BARCLAY MEDICAL OFFICE BUILDING

STAFF REPORT #3

June 8, 2022

PLANS UNDER REVIEW: Site Plan, Map 246 / Lot 1, Barclay Medical Office Building, 2 Stonemill Drive, Hudson, New Hampshire; prepared by: Maynard & Paquette Engineering Associates, LLC, 31 Quincy Street, Nashua, NH 03060; prepared for: Warren R. Barclay, Trustee of Warren and Suzanne Barclay Revocable Trust, 24 Chalifoux Road, Hudson, NH 03051; consisting of 5 sheets and general notes #1-23 on Sheet 1; dated December 29, 2021; last revised May 5, 2022.

SITE PLAN MAP 246 / LOT 1
BARCLAY MEDICAL OFFICE BUILDING
2 STONEMILL DRIVE
HUDSON, NEW HAMPSHIRE

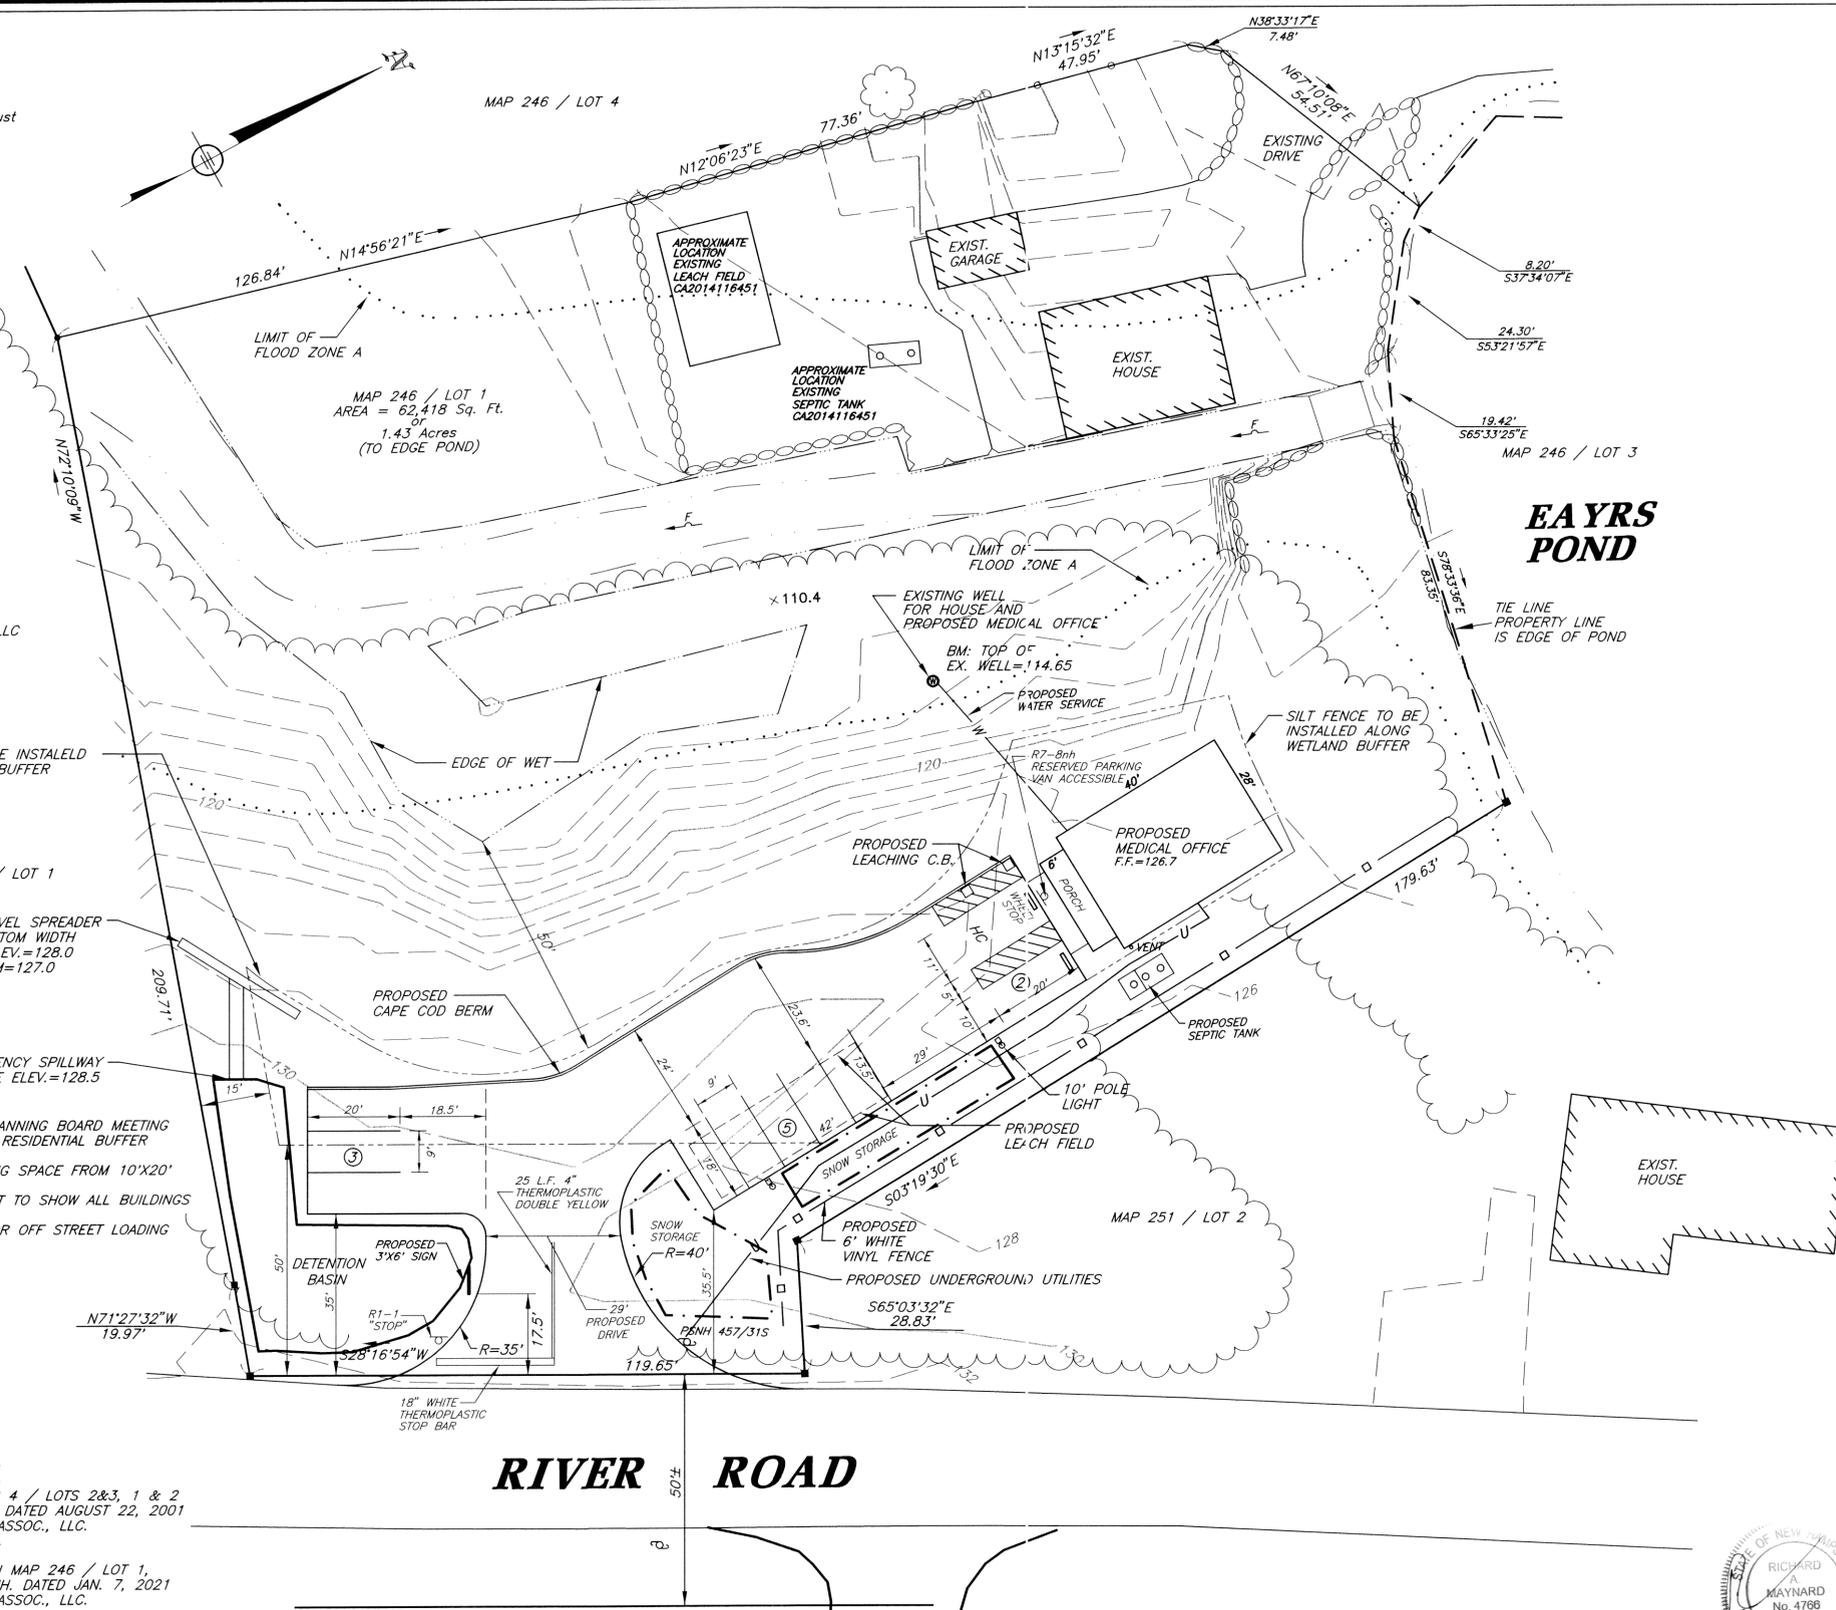
The Applicant previously withdrew a waiver request for reduced parking width aisle since their April 11, 2022 plan set appeared to provide the requisite width. However in the most recent plan set the width has been reduced to avoid wetland buffer impacts. Further, while the April 11th set

showed a 24-foot aisle width for almost all spaces, the northern most space of the grouping of 5 spaces does not have a 24-foot aisle. A waiver from §275-8.C.(5)(a) would be required for the current plan set to be approved.

I move to grant a waiver from § 275-8.C.(5)(a), to allow the parking aisle width for perpendicular parking spaces to be less than 24-feet, based on the Board’s discussion, the testimony of the Applicant’s representative, and in accordance with the language included in the submitted Waiver Request Form for said waiver.

GRADING PLAN MAP 246 / LOT 1
**BARCLAY MEDICAL OFFICE BUILDING
2 STONEMILL DRIVE
HUDSON, NEW HAMPSHIRE**

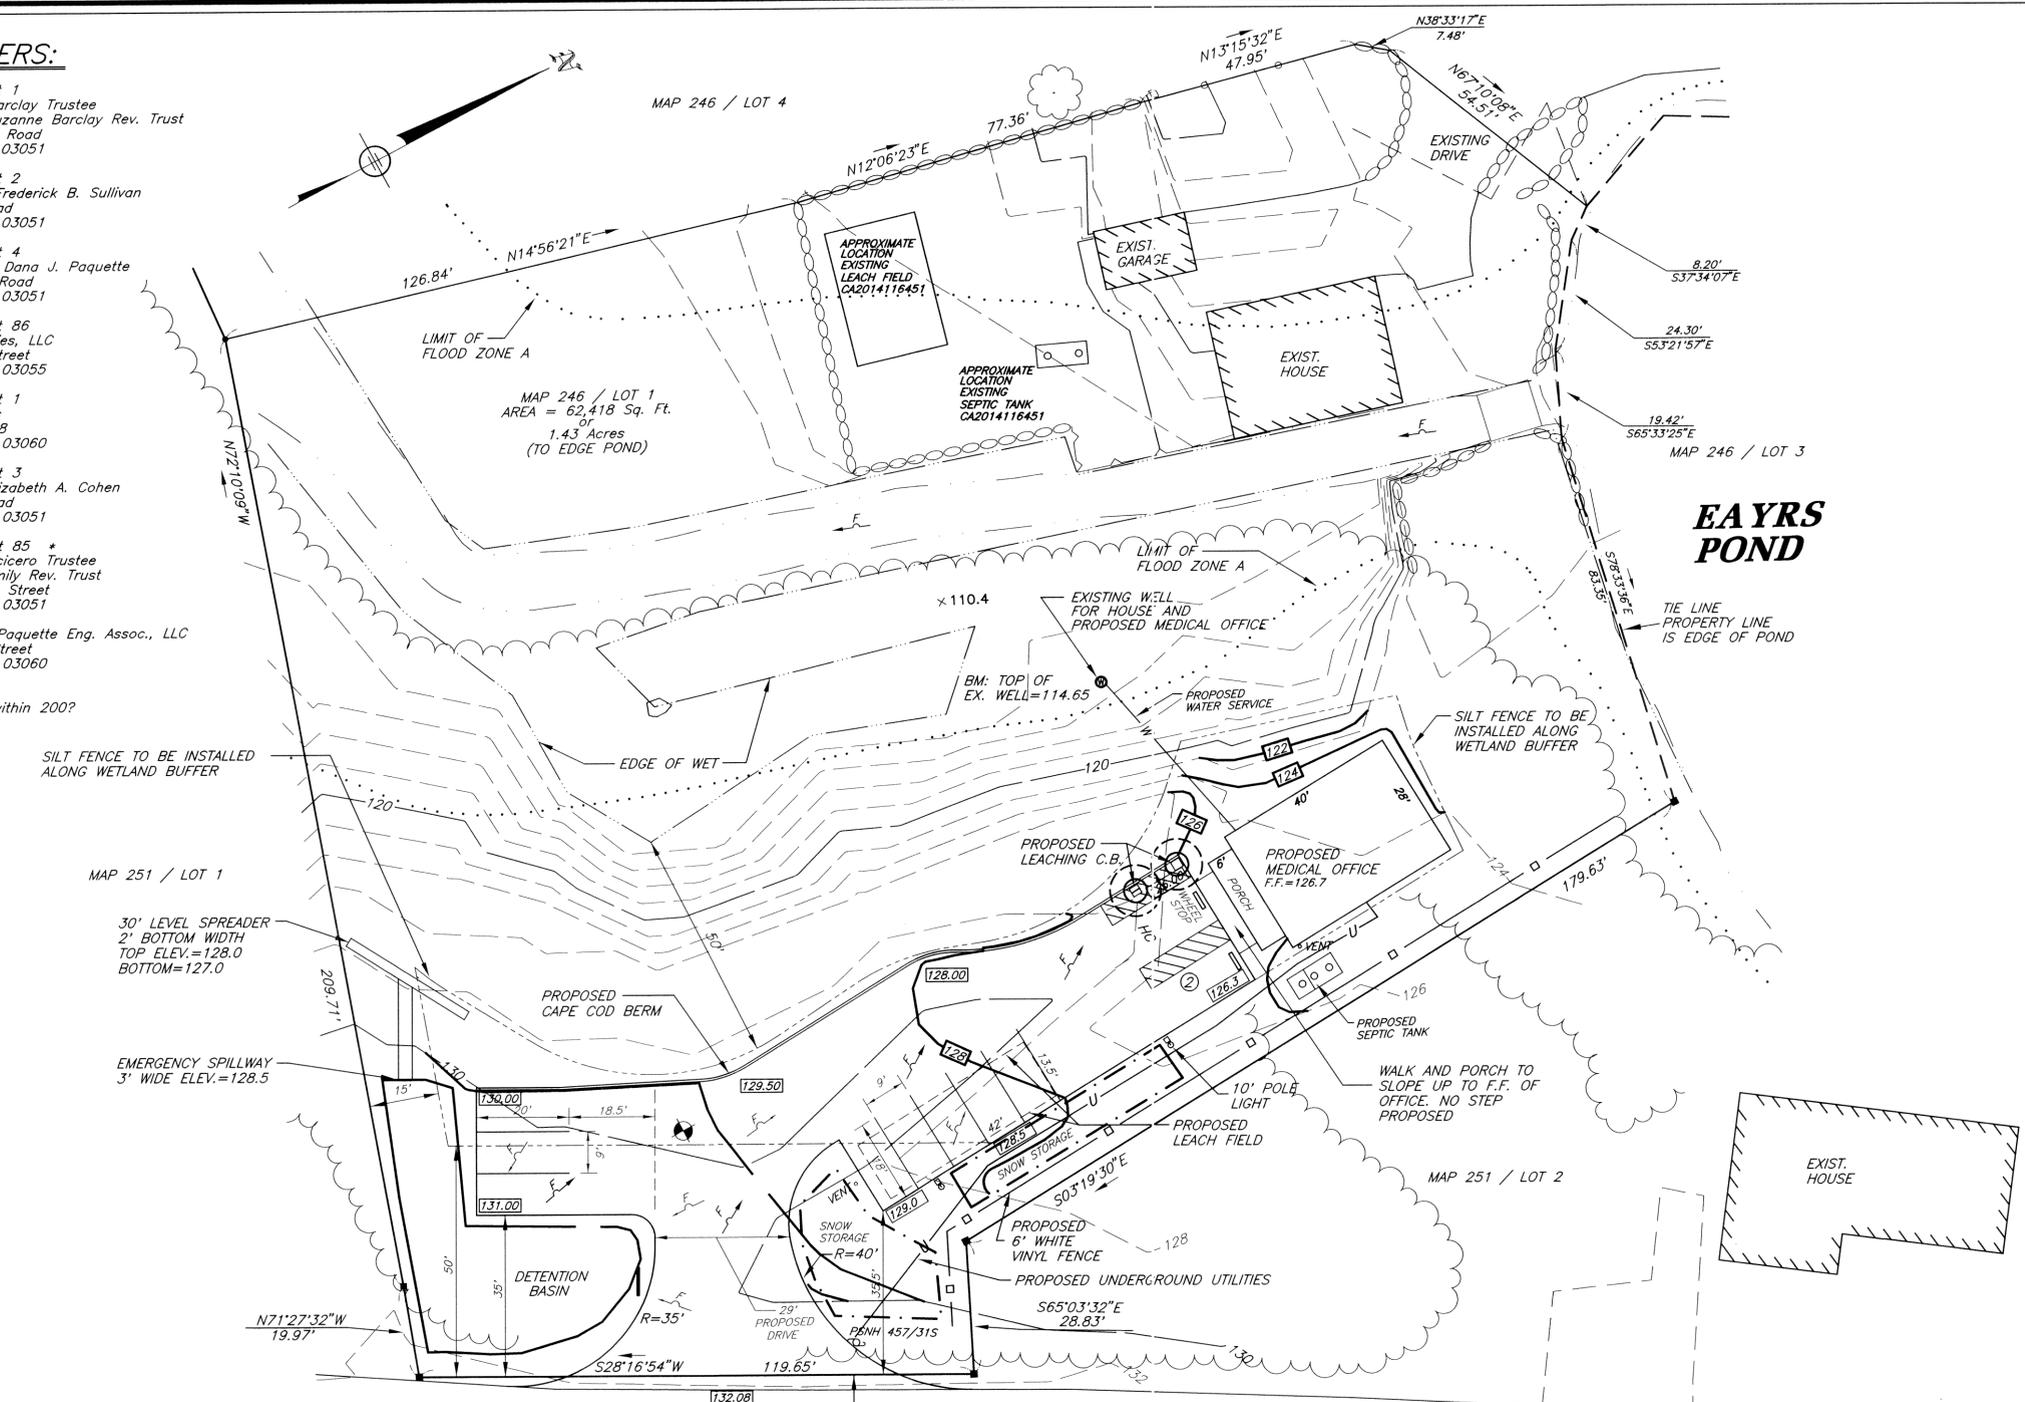
- The second threshold is that the proposed development will discharge stormwater into wetland areas. The proposed development shows the emergency spillover flowing into the wetland buffer, upland from the wetland. The Applicant contends that there is no “direct” discharge into the wetlands, however the regulations do not discriminate between direct or indirect discharge. It is the interpretation of the peer review engineer and the Town Engineer that the design discharges into wetland, therefore this threshold is met. The Board may consider if it accepts the interpretation made by the Applicant or Staff/Peer Reviewer.

- 6 – With regard to Hudson Zoning Ordinance section 290-5-A (opening paragraph), and past construction, there is NO direct discharge to any area wetlands and surface waters. The storm drainage is directed to either leaching catch basins or a detention basin – in other words the stormwater from the developed areas is directed into the ground, NOT into wetlands or resurface waters.
